LFPS Tx Low Power

Mandate: Informational -> Required

Effective Date: Sep, 2019 -> May, 2020

LFPS Rx Detect Threshold

Figure 3-34 Recommended Differential Insertion Loss Requirement

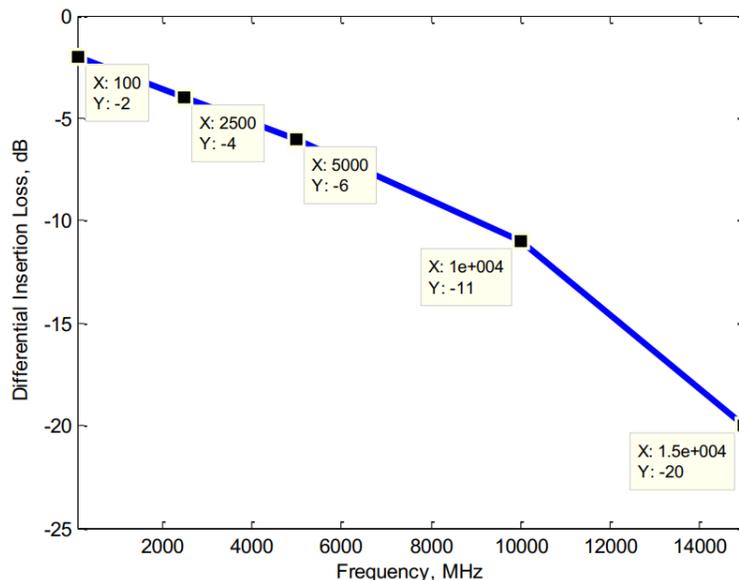
In case of **captive cable devices** it is considered that the captive cable shall comply with USB Type-C Specification section 3.7.2.1.1

LFPS Max. Frequency as defined below is 50MHz thus the expected IL is -1dB

Low power transmitter at TP2 is not accessible thus effective TP3 shall comply with the following limit:

V _{TX-DIFF-PP-LOW}	Low-Power Differential p-p Tx voltage swing	0.352(Min.)	V	Refer to Section 6.7.2. There is no de-emphasis requirement in this mode. De-emphasis is implementation specific for this mode.
-----------------------------	---	-------------	---	---

- For **captive cable devices** Repeat steps **1 to 4** and compare tburst, trepeat, tperiod, tRiseFall2080, Duty cycle, V_{CM-AC-LFPS}. V_{TX-DIFF-PP-LFPS-LP} is compared against specified limit in Table 1.1-1. A **Captive device** will pass if in compliance to this step.
